Subject: Docket Nos. 50-361 and 50-362
San Onofre Nuclear Generating Station, Units 2 and 3

ATTACHMENT I

Notice of Violation

POST-WELD HEAT TREATMENT PROCESSES

Figure D-1. VERTICAL PIPE ENDS BLOCKED 40F/INCH

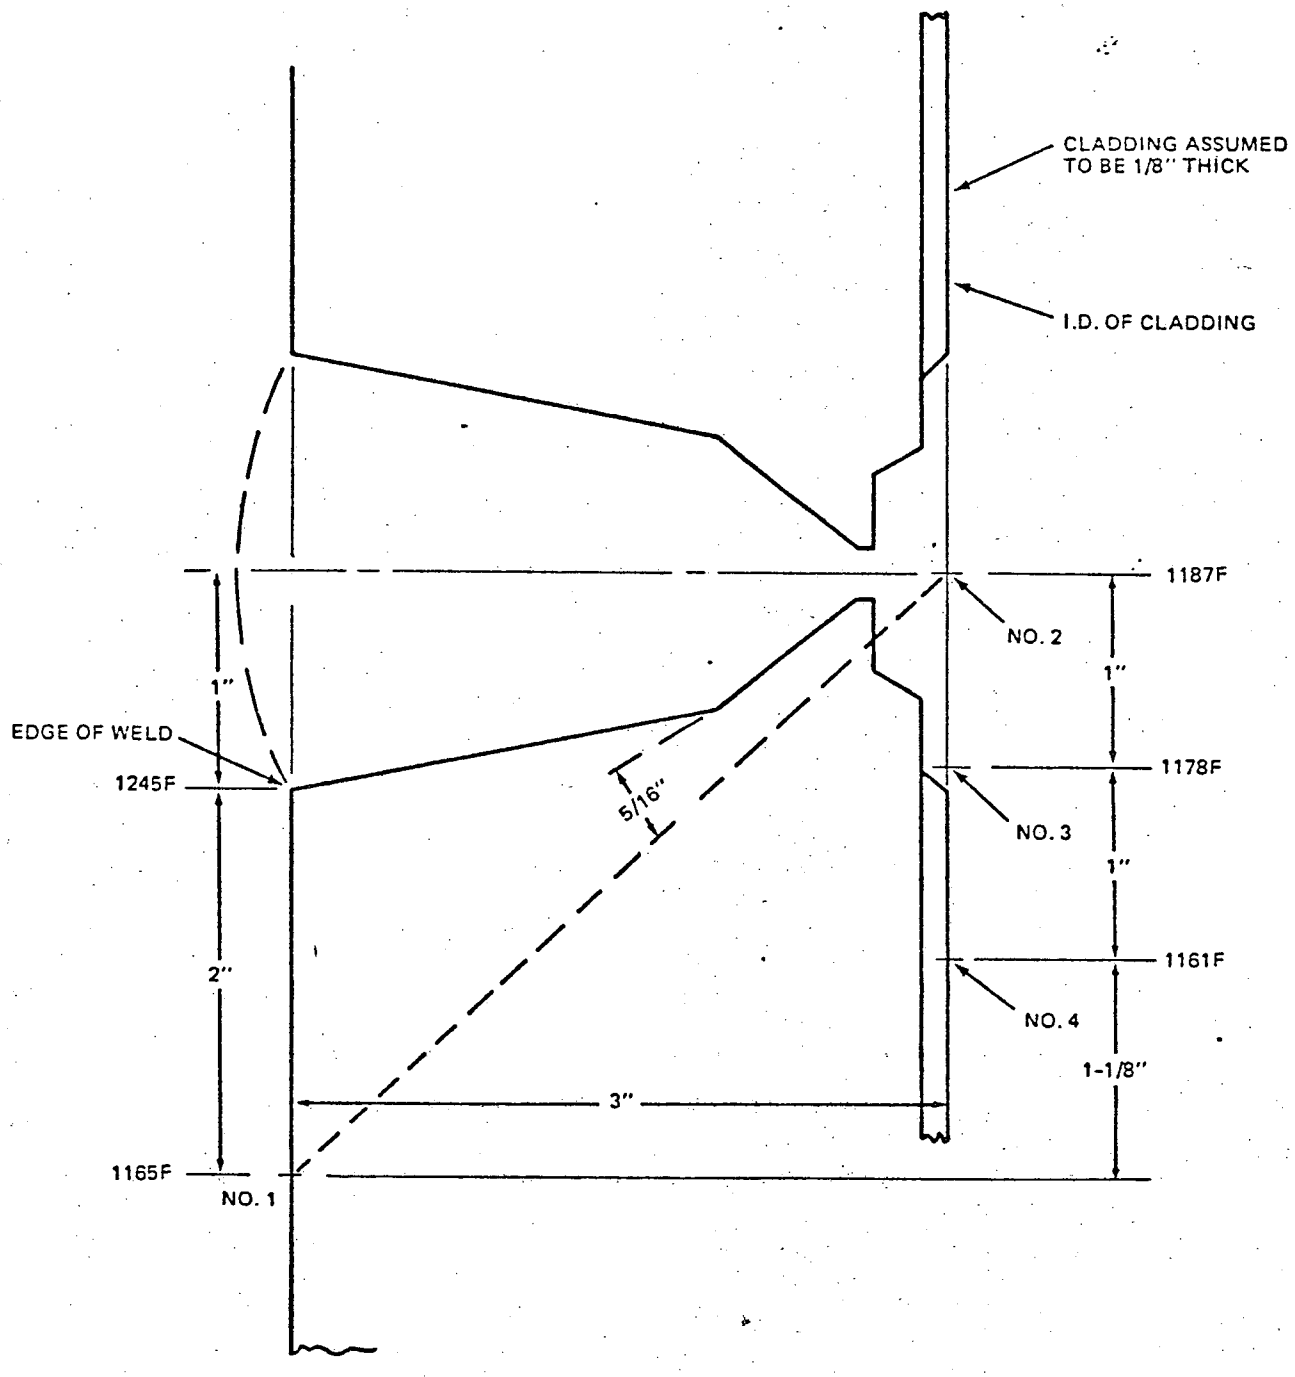
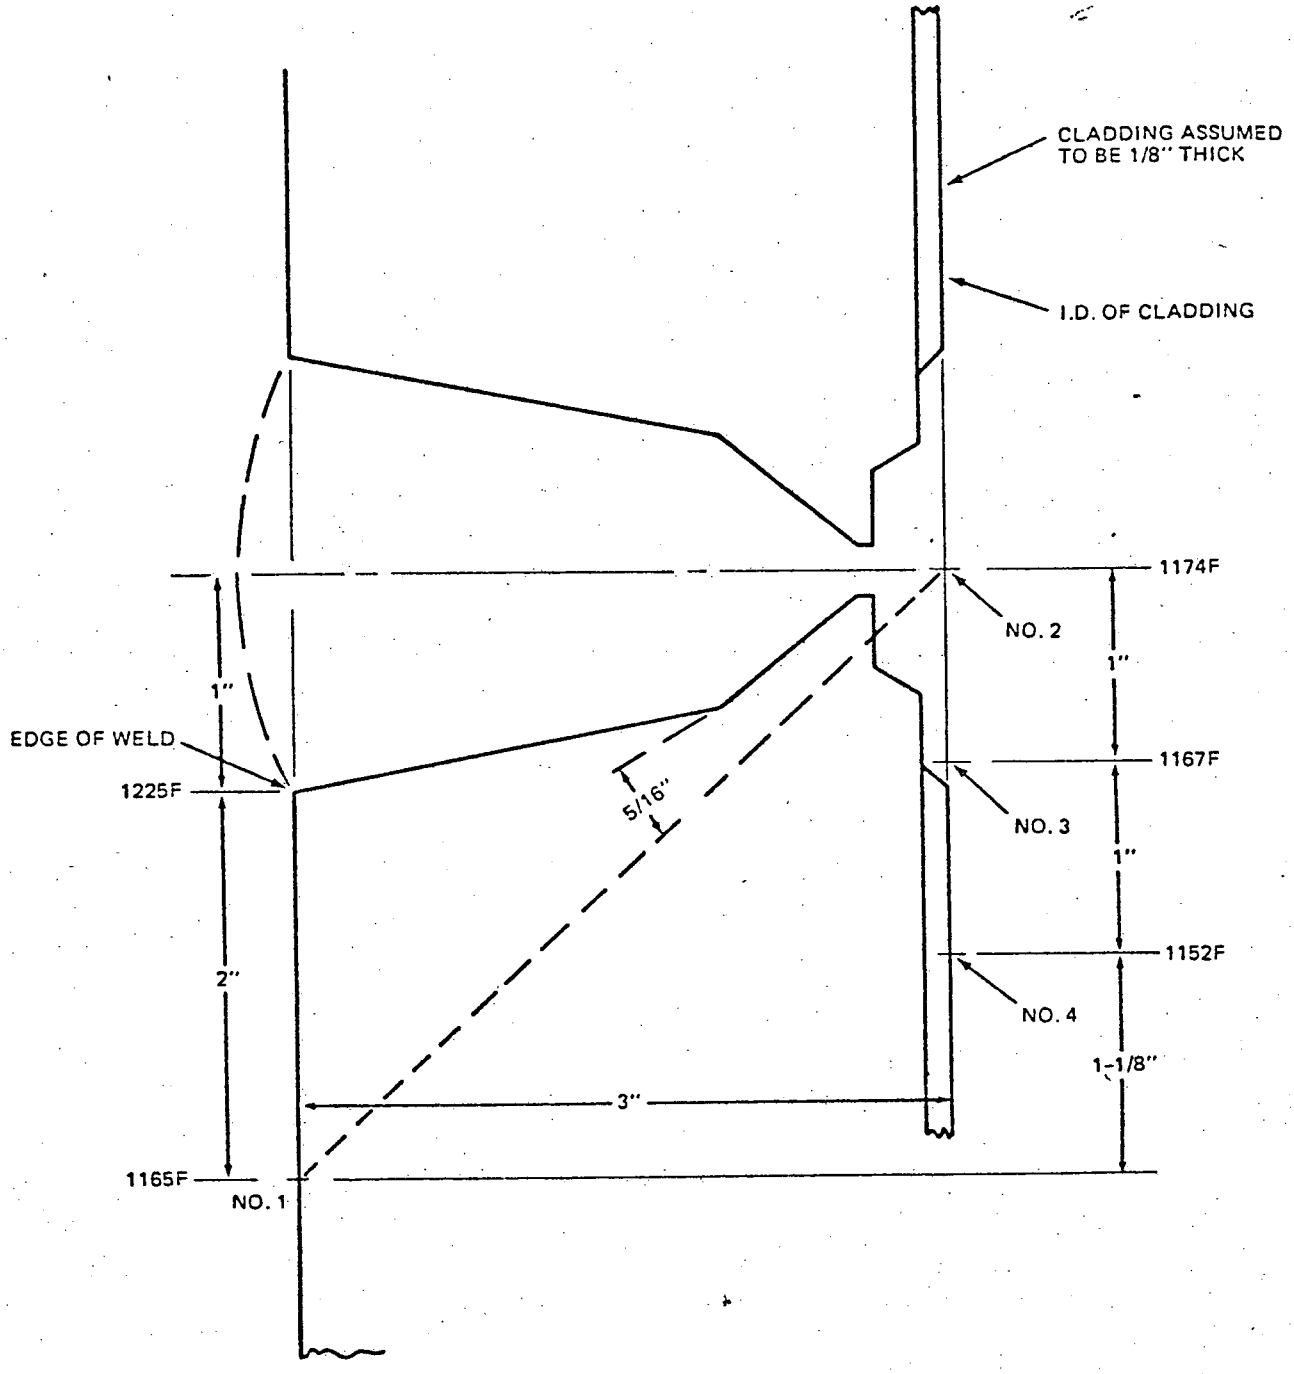
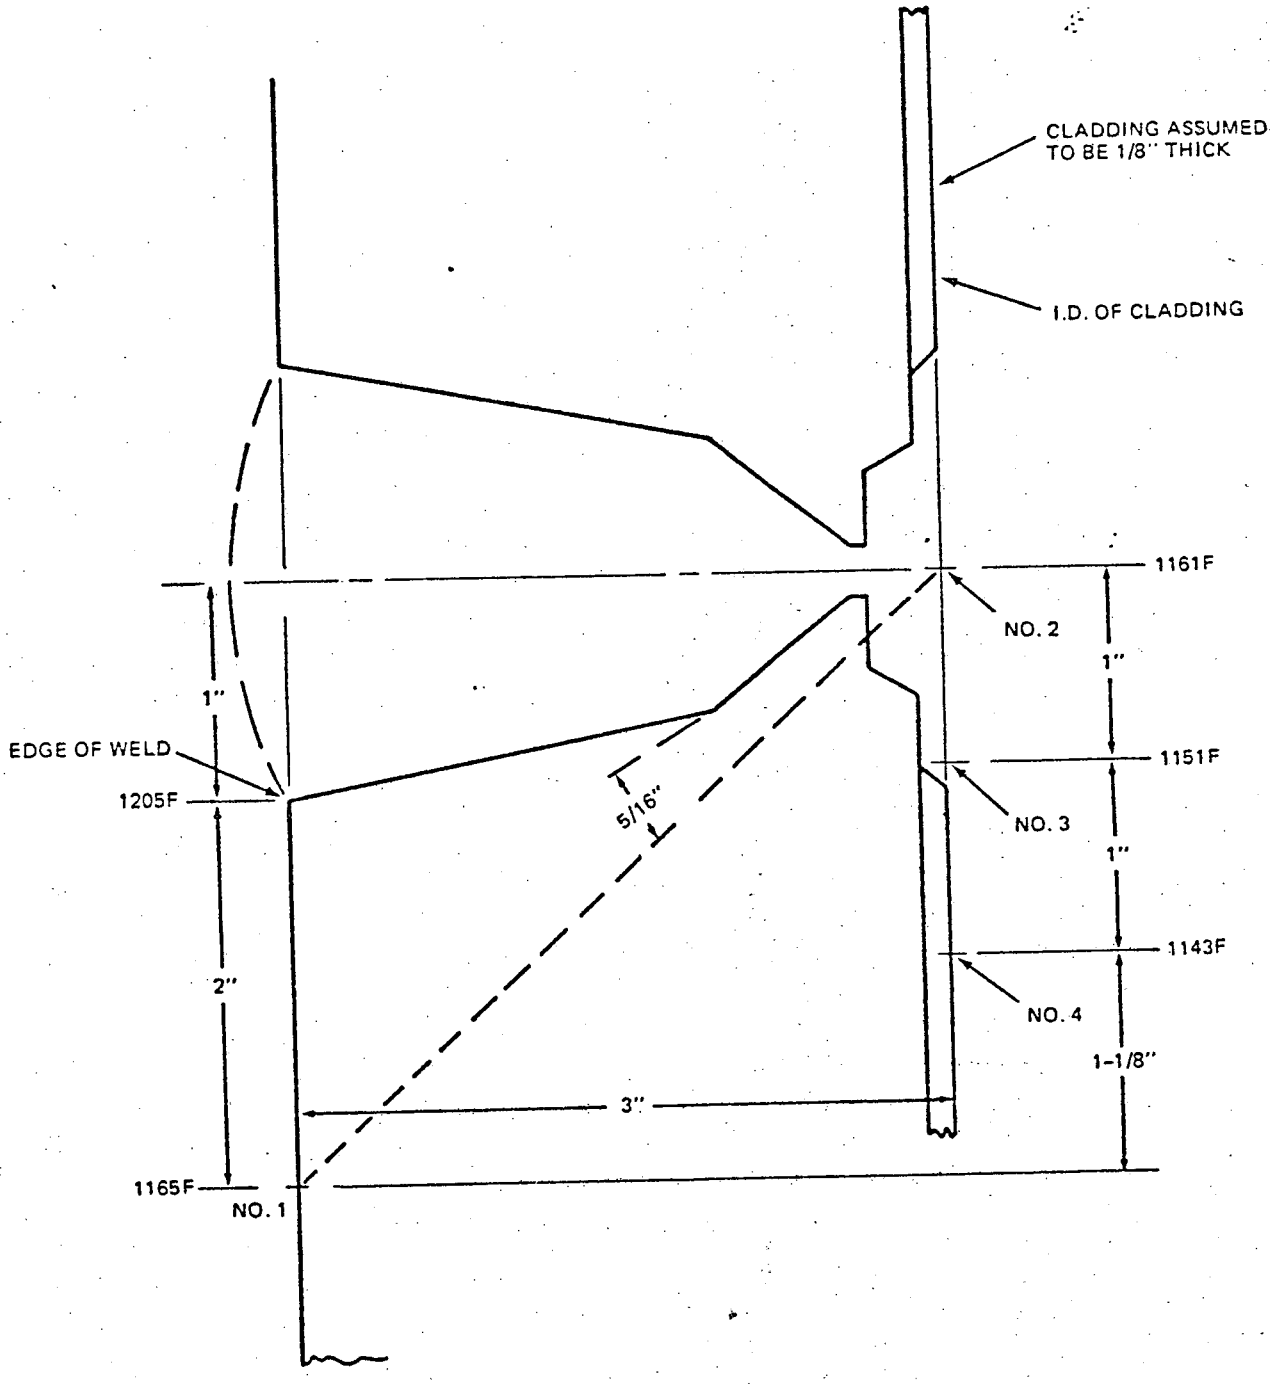
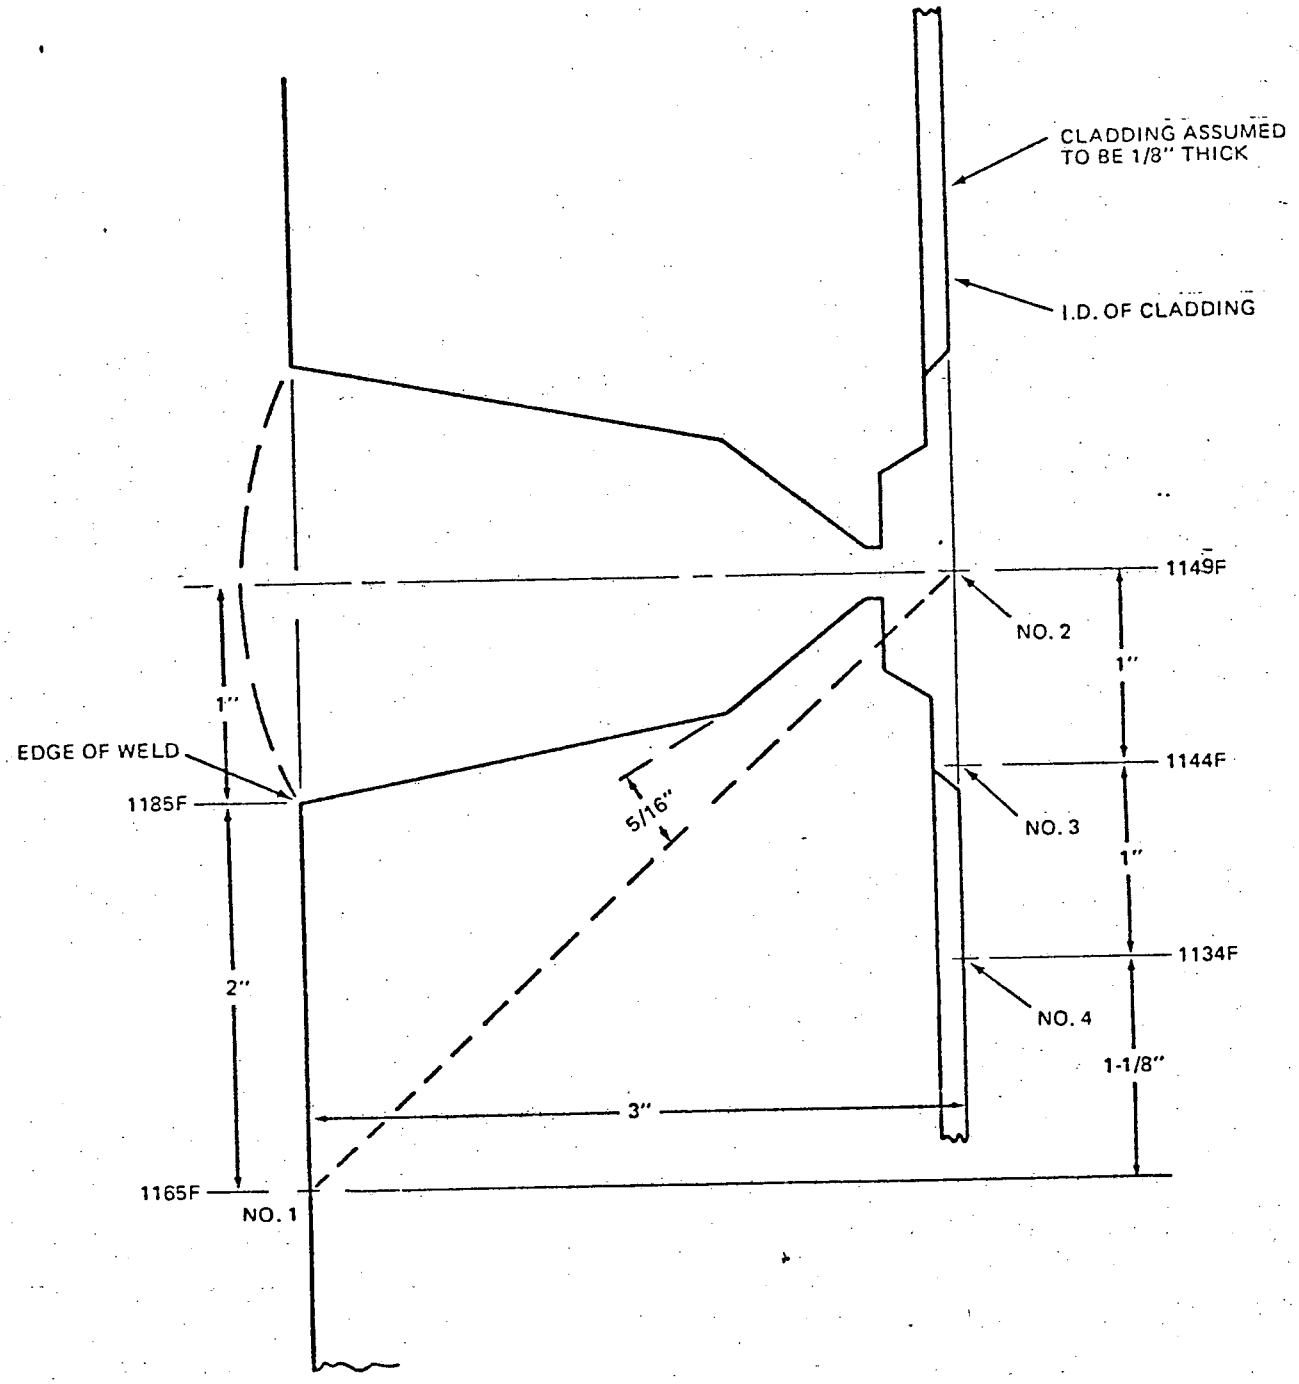
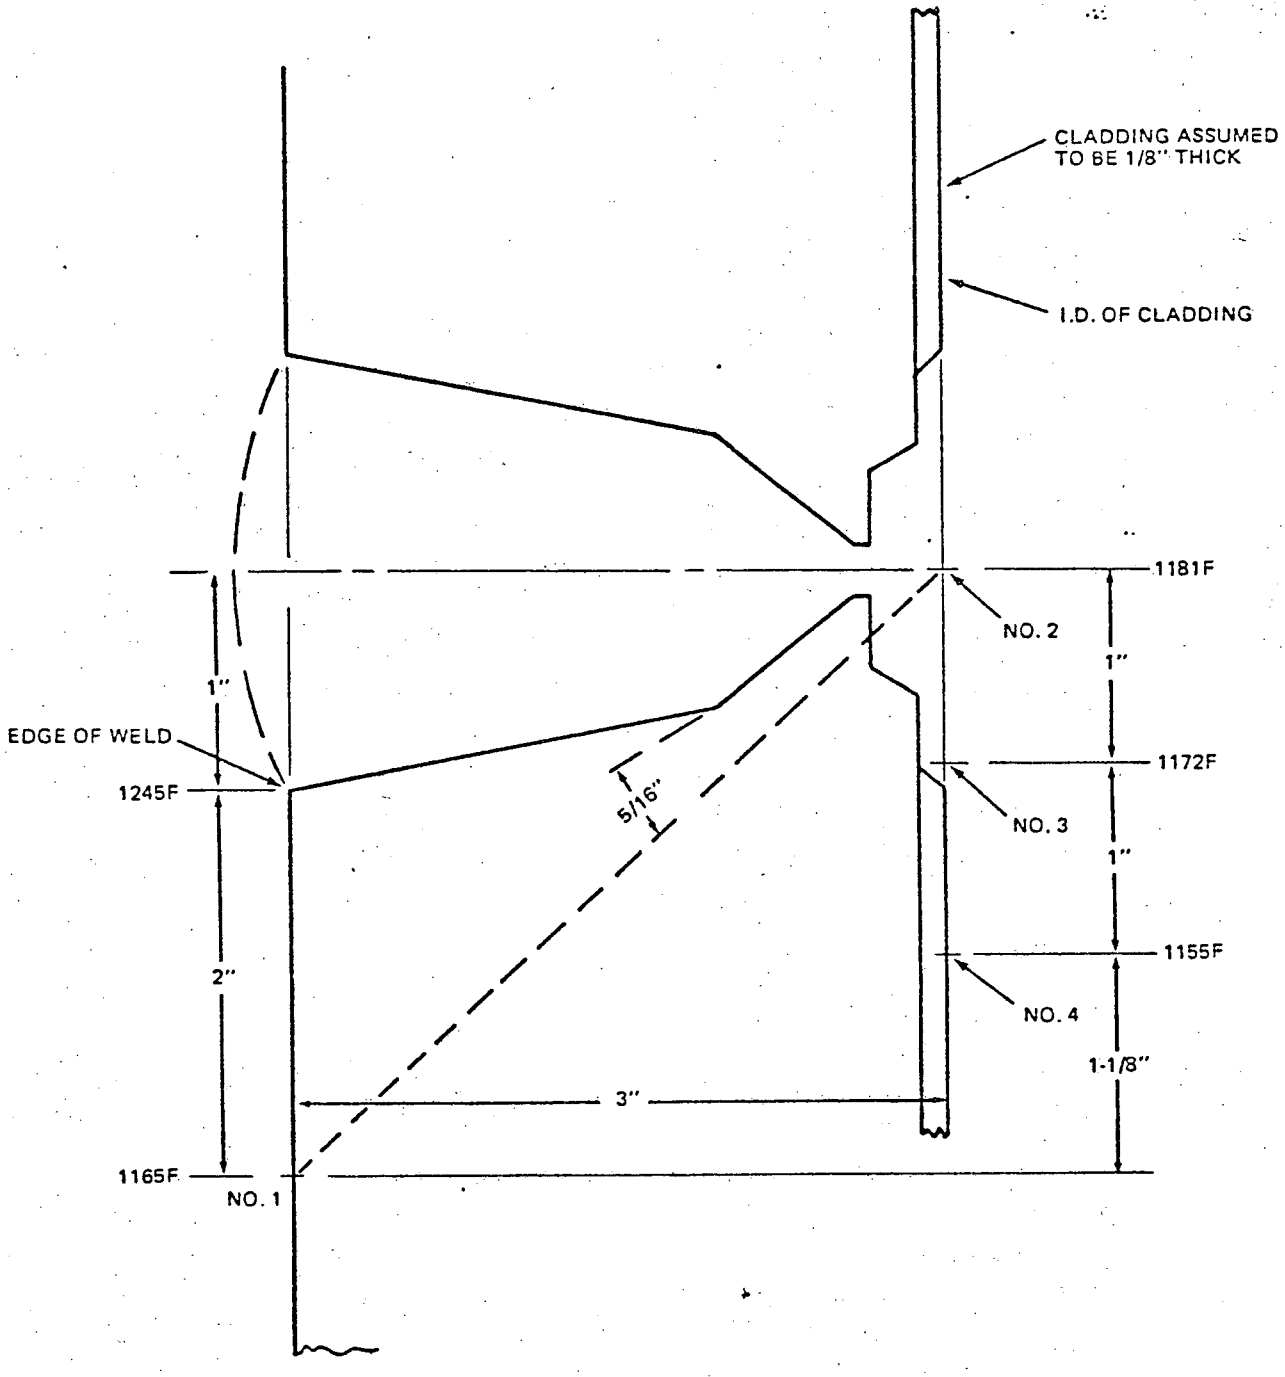
Contrary to the above, as of February 5, 1979, the post weld heat treating procedure using the quartz lamp technique had not been qualified before use to demonstrate that the minimum heat treating temperature of 1100°F, a design requirement, was met during the post weld heat treatment of main steam piping and reactor coolant piping welds. This procedure had been used since mid-1977 for heat treating the aforementioned welds at Units 2 and 3.

Figures D-1 through D-4 and D-5 through D-8 are in Appendix 4D and show the predicted inside pipe diameter temperatures for outside pipe diameter temperature gradients of 40, 30, 20 and 10F per inch. Outside pipe temperature gradients of 20 and 30F per inch are usually encountered in production welds. The 10 and 40F per inch gradients were modeled to bound the analysis. The pipe modeled had a 3-inch wall thickness, was in a vertical configuration, and had ends both blocked and unblocked. In all cases, a 10F/inch outside gradient yielded the lowest internal temperature. This configuration would yield the largest through-wall temperature gradients. With a reference temperature 2 inches from the weld edge of 1165F, the lowest internal temperature, 1 inch from the weld centerline (outside heat affected zone), calculated was 1138F with pipe ends unblocked. This is a maximum through-wall temperature gradient of 37F and confirms that the 3-inch and smaller wall thickness pipes are acceptable since these pipes were all heat treated at reference temperatures at least 40F above the required temperature. The effect of not blocking the ends of the pipe is an increase in the through-wall temperature gradient of 6F for the 3-inch wall thickness vertical piping.

The computer model predicted a temperature difference of minus 27F between the control thermocouple on a 3-inch thick vertical axis pipe and the internal weld centerline. The installation test data from Appendix C showed this temperature difference on a 3-3/8 inch thick (compared to 3-inch thick) vertical axis pipe to be 35F. This shows good correlation considering the thicker wall pipe, the difference in thermocouple placement, and the accuracy of the recorders. The good correlation justifies use of the program to predict the internal temperatures on thicker pipe.
